NATIONAL FIRE PROTECTION ASSOCIATION

TO: Code-Making Panel 3

SUBJECT: NEC® First Draft Technical Committee FINAL Ballot Results (A22)

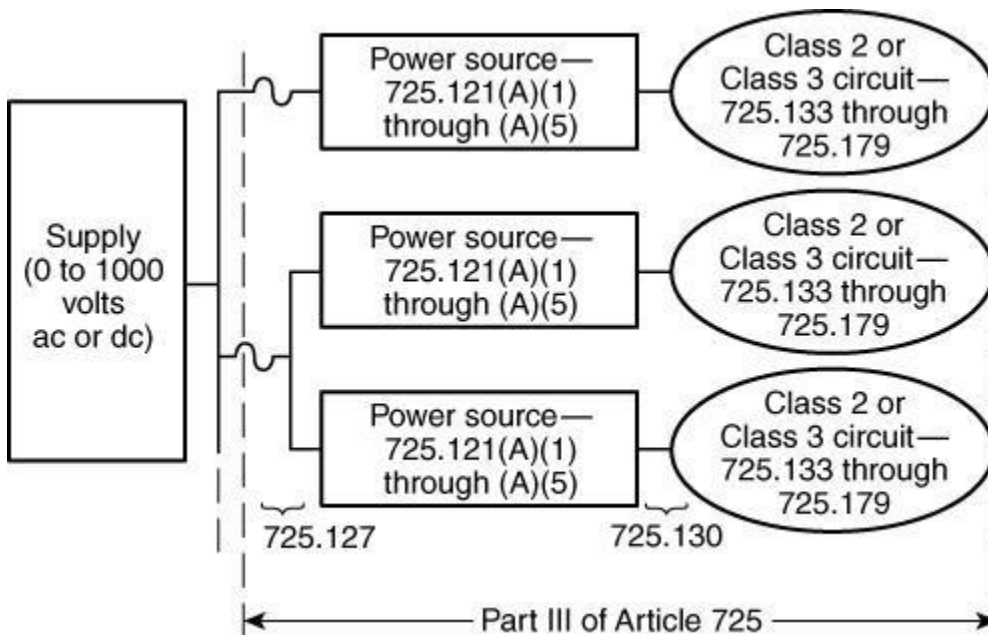
Informational Note No. 1: Informational Note Figure 725.121 illustrates the relationships between Class 2 or Class 3 power sources, their supply, and the Class 2 or Class 3 circuits.

Figure Informational Note Figure 726.121 Class 4 Circuits.

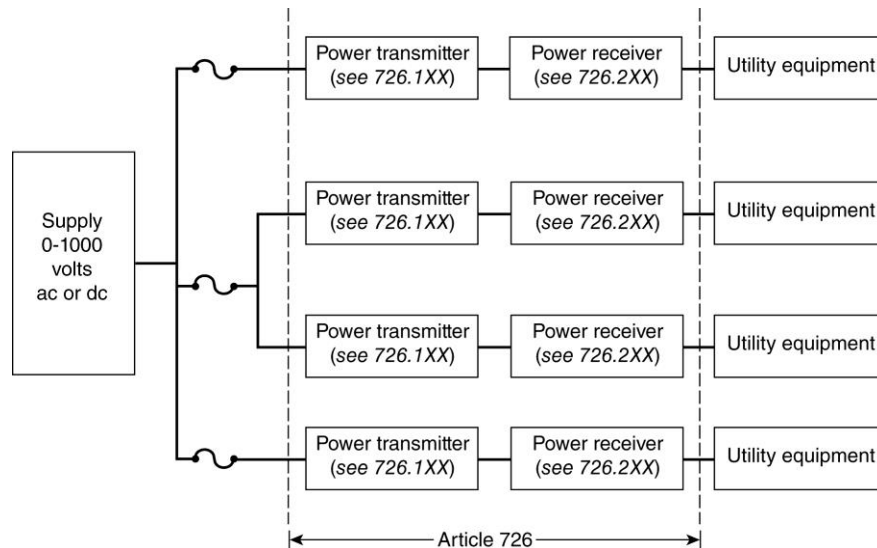
Informational Note No. 1: Informational Note Figure 726.121 illustrates the relationships between Class 4 power transmitters (power sources), Class 4 power transmitters (power sources) supplies, Class 4 circuits, Class 4 power receivers, and utilization equipment.
